SITE DEVELOPMENT PLANS FOR GROVE CITY FAMILY DENTISTRY PARKING LOT EXPANSION

4068 GLADMAN AVENUE
GROVE CITY, OHIO
DECEMBER, 2014

Staff has reviewed your development plan application for the Grove City Family Dentistry Parking Lot Expansion located at 4068 Gladman Avenue. The control number for this application is #201412220073 and should be referenced on any future correspondence concerning this matter.

Re: Application #201412220073
Grove City Dentistry

DEVELOPMENT PLAN
 Development Plans For:
GROVE CITY FAMILY DENTISTRY
 4068 GLADMAN AVENUE - GROVE CITY, OHIO
 NOV 2014
 1"=20'
 SEI#3044
3
5

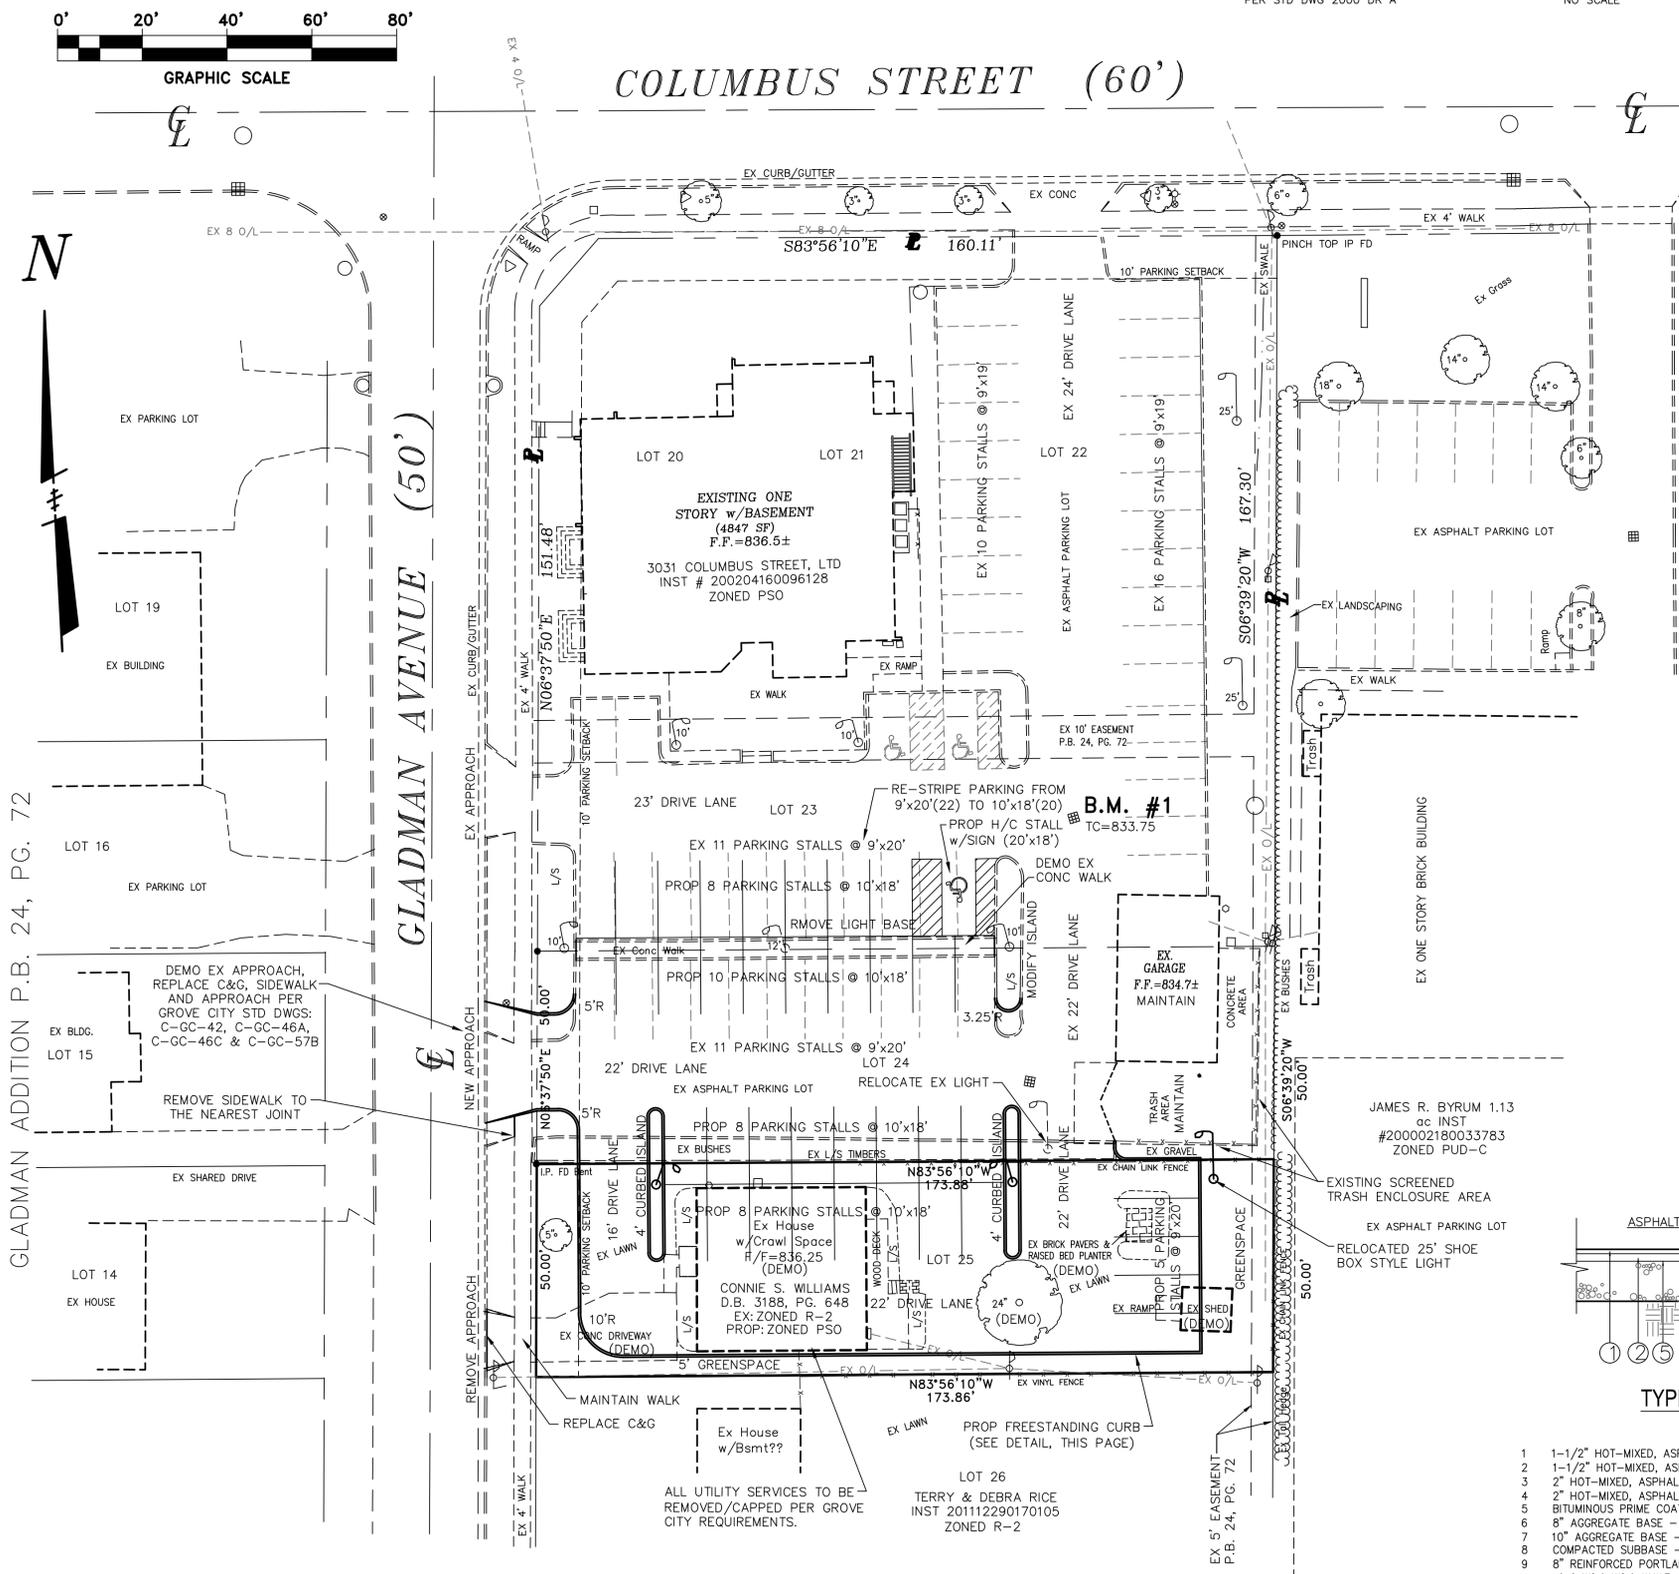
1. A photometric plan should be submitted showing a minimum of 0.5 footcandles in all pedestrian and vehicular areas.
2. Details for any new lighting fixtures should be provided. New fixtures should match existing fixtures on the site and should be located to reduce impacts on the adjacent residential properties.
3. The landscape plan (Sheet L1.1) appears to show the proposed landscaping on the adjacent property to the south. Plans should be adjusted to show all improvements on the applicant's property.
4. The proposed parking lot setbacks from the southern and western property boundaries will require deviations through Planning Commission and City Council. Staff would be supportive of the proposed deviations, as the proposed setbacks are consistent with variances granted by the BZA in 2009 for the previous parking lot expansion.

5. Per 1106.1 of the OBC, accessible parking spaces; a total of three parking stalls are required for lots with 51-75 total spaces.

7. The proposed new parking spaces must have an island bed on either side to define the parking areas. Each island will then need to have one minimum 2" caliper medium or large class tree planted in it. A tree is also needed at the end island on the Northeast corner near the dumpster and the screening around the dumpster will need to continue around to the south side (1136.08).

8. Need a lighting plan approved by the City.

- 1) A Lighting Plan has been added to the plan set, which shows the photometrics.
- 2) Lighting details are on the New Lighting Plan.
- 3) The Landscape Plan has been corrected and revised.
- 4) It is assumed the Variances to setbacks are to be granted with the re-zoning.
- 5) A third Handicap parking stall has been added to the site plan.
- 6) The plans show a 5' setback on the south and the same landscape items that were approved with the previous variance. We assume the re-zoning will include the variance to setback and landscaping.
- 7) The hatched islands at the ends of the new row of parking have been changed to landscaped islands with plantings shown on the Landscape Plan.
- 8) A Lighting Plan has been added.
